APPLICANT'S RESPONSE TO MATTERS RAISED IN THE COUNCIL ASSESSMENT REPORT

OPAL RESIDENTIAL CARE FACILITY AT 94-100 EXPLORERS WAY, ST. CLAIR

Job No. 19-121A
Opal St Clair - Response to proposed grounds for refusal
August 2022

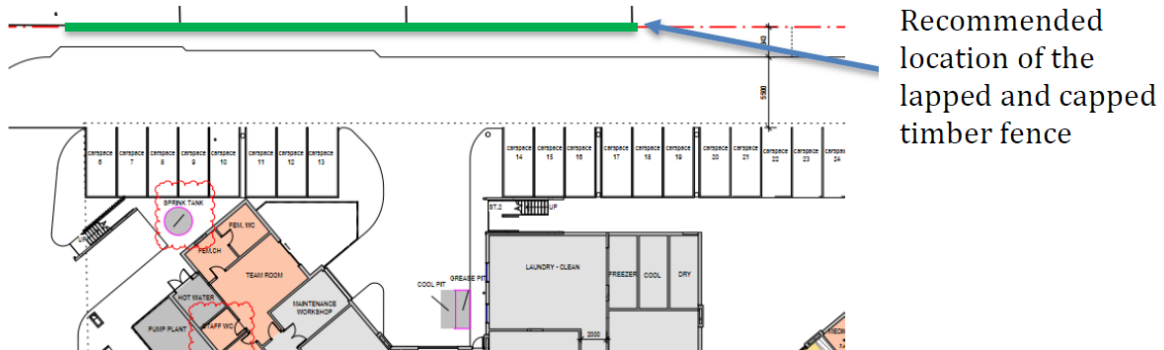
The acoustic consultant recommended a boundary fence of 2.2 metres adjacent to the loading area entry as shown in the following extract from the acoustic impact assessment to ensure that the noise criteria could be met from this activity.

The submitted DA drawings indicate that the 2.2m high fence extends along the full length of the western boundary adjoining the three existing dwellings. A condition of consent restricting the area of the fence to that shown above is recommended. A fence of this height is higher than the typical rear boundary fence height of 1.8 metres but is considered acceptable in a residential environment.

View 8

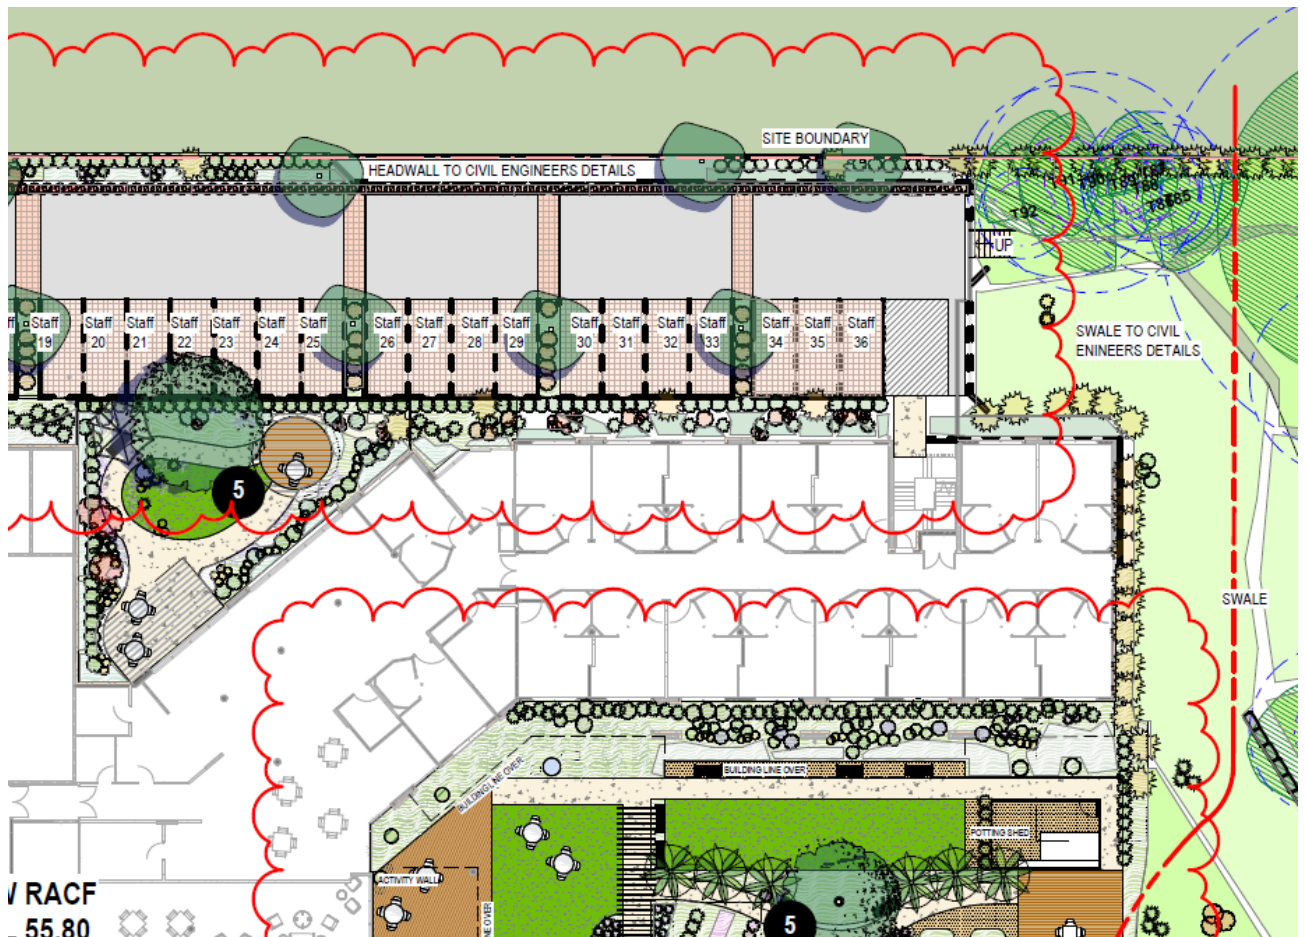
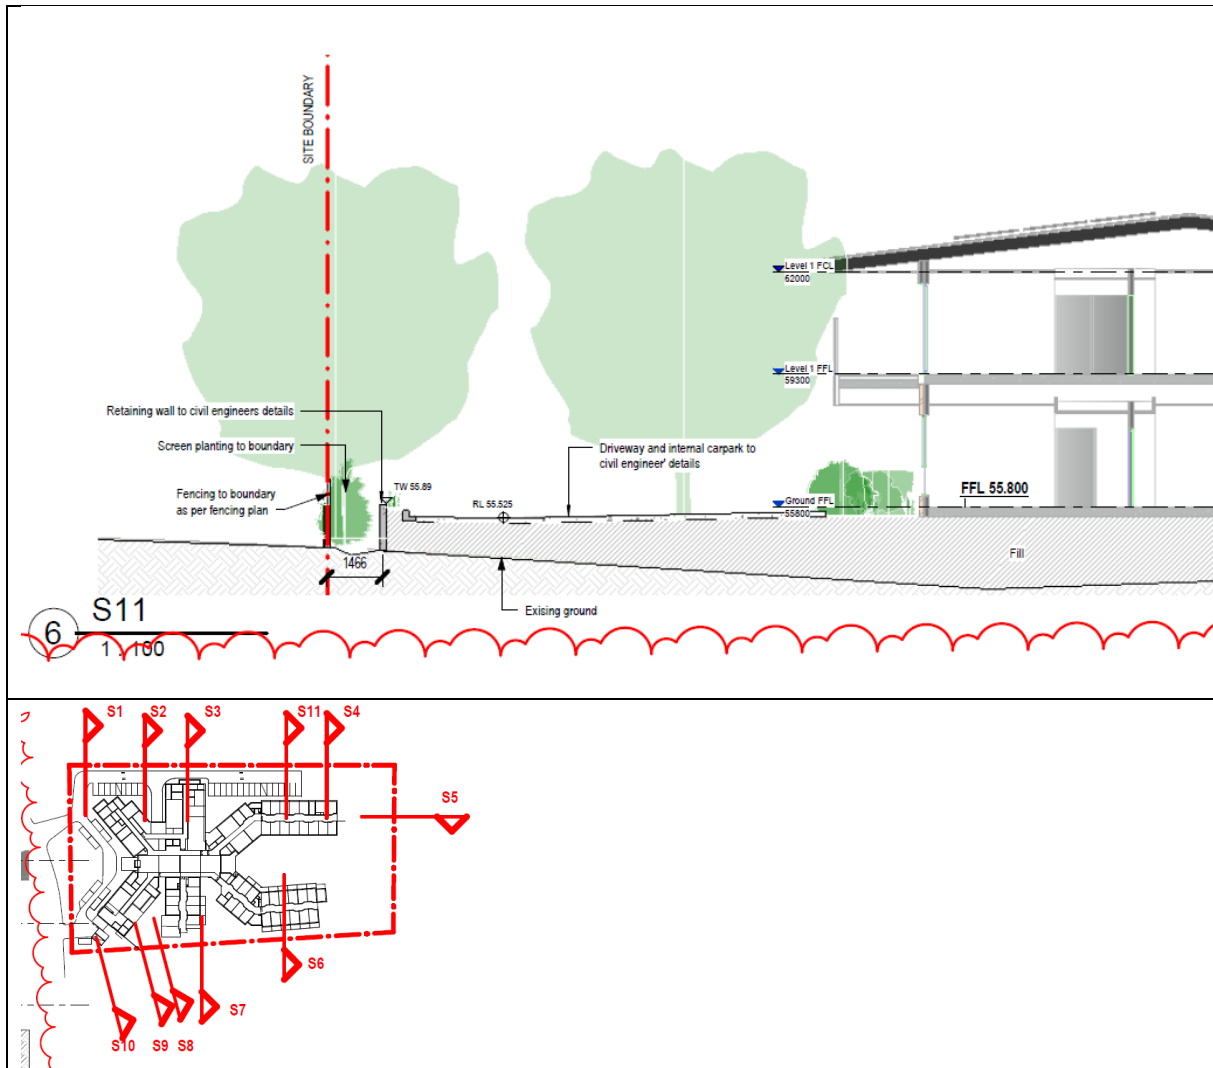
The relationship of the northern portion of the car park to the adjoining site can be seen in the following extracts from the development application drawings.

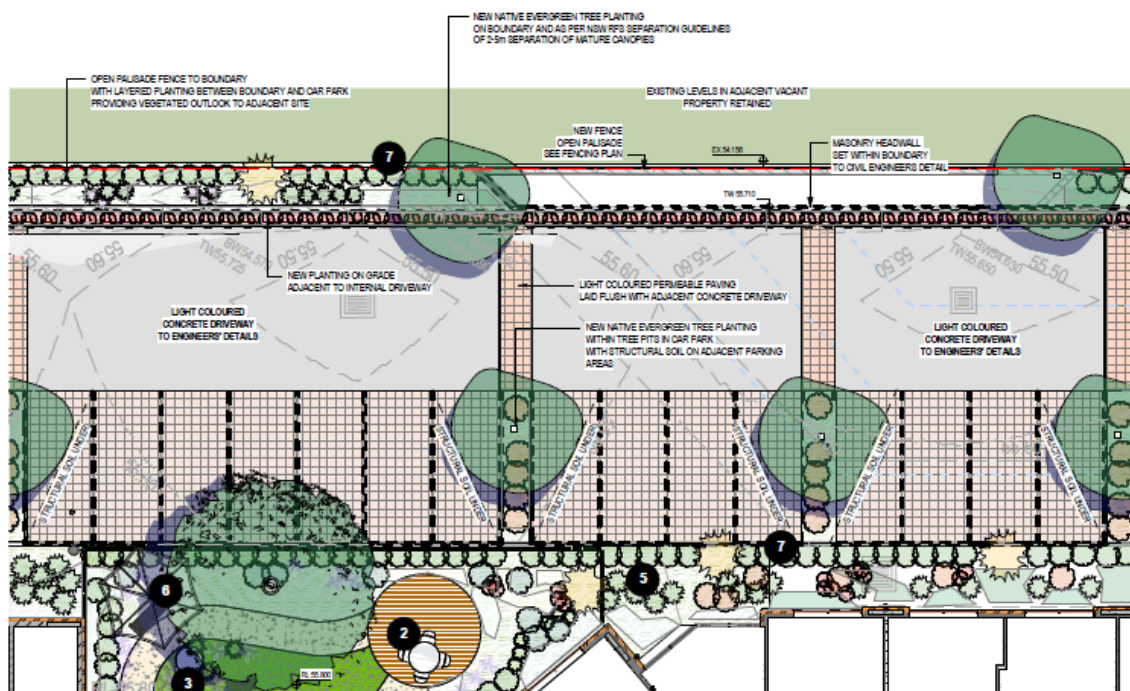
- a. *Elements of external finishes being unclear, including in relation to specifications of the glazed privacy screens, sections of feature brickwork and driveway pavement;*

Elements of external finishes are clearly shown on the DA drawings. There are no glazed privacy screens proposed.

One section of feature brickwork has been proposed and discussed with Council officers. The DA included the below design response to Council's request for further articulation of the south east wing façade. The proposed design response is as follows as shown on the DA drawings.

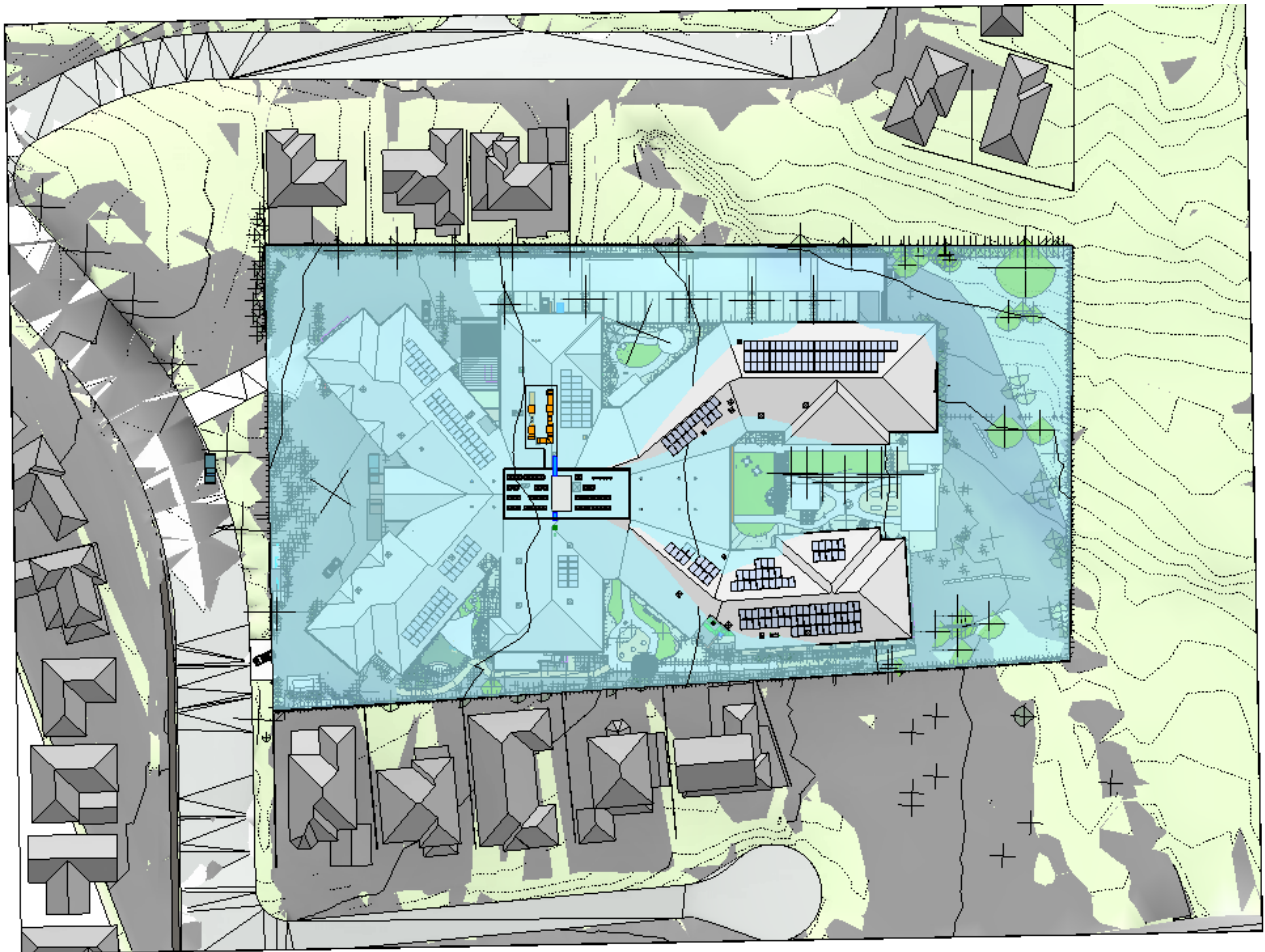
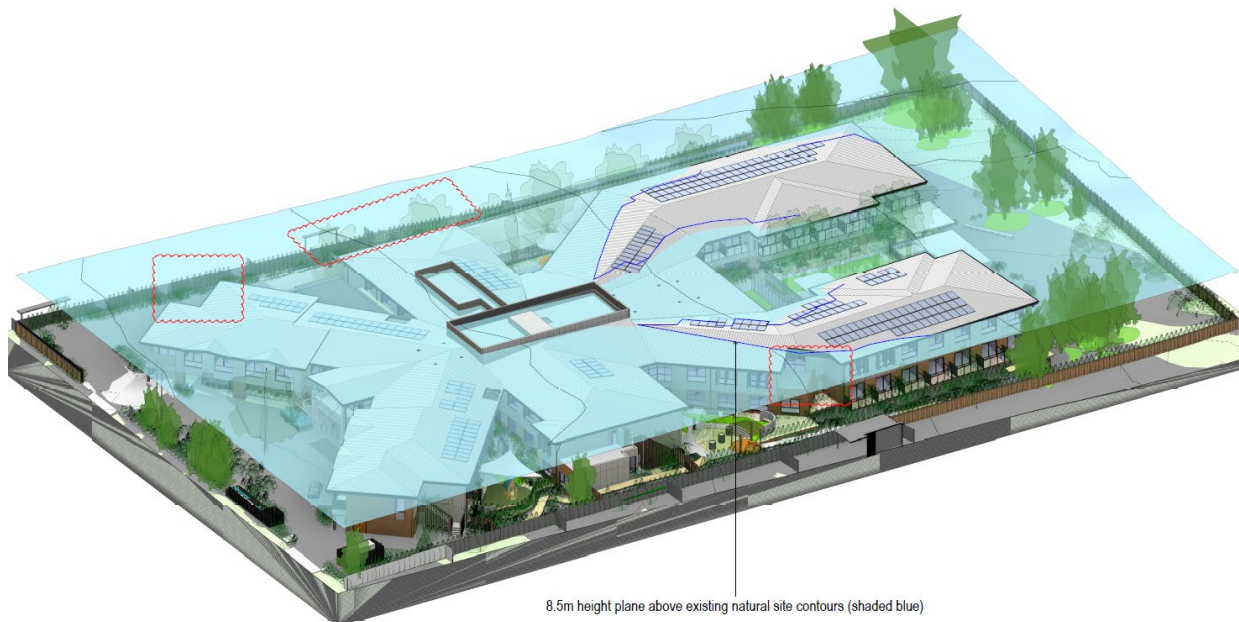
Clause 4.6 not adequate because development is not consistent with the objectives of the zone or in the public interest.

The following diagram identifies those elements of the development that do not comply with the maximum building height development standard in the LEP. This is the same as the axonometric view lodged with the development application also repeated below.

The development complies with the height control to the street frontage an adjoining the existing residential properties. The non-compliance relates predominantly to the roof and roof mounted plant which are mostly recessed behind the building façade and eaves height and thus would not generally be visible from the adjoining public domain or from adjoining sites. The non-compliant plant elements are integrated into the design of the building with the plant areas recessed into the roof with roof cut-outs provided for plant areas which are to be screened. The building has been designed with a pitch roof form consistent with the residential character of the area.

The height the building in relation to street frontage is compatible with the streetscape. A two storey dwelling is allowed under the LEP, the building presents as a two storey element to the street. The new building presents as a two storey building mass predominantly along the east and west facades, with the height exceedance occurring only at the rear of the property adjacent to open space and the motorway with no impacts to neighbours regarding overshadowing or privacy.
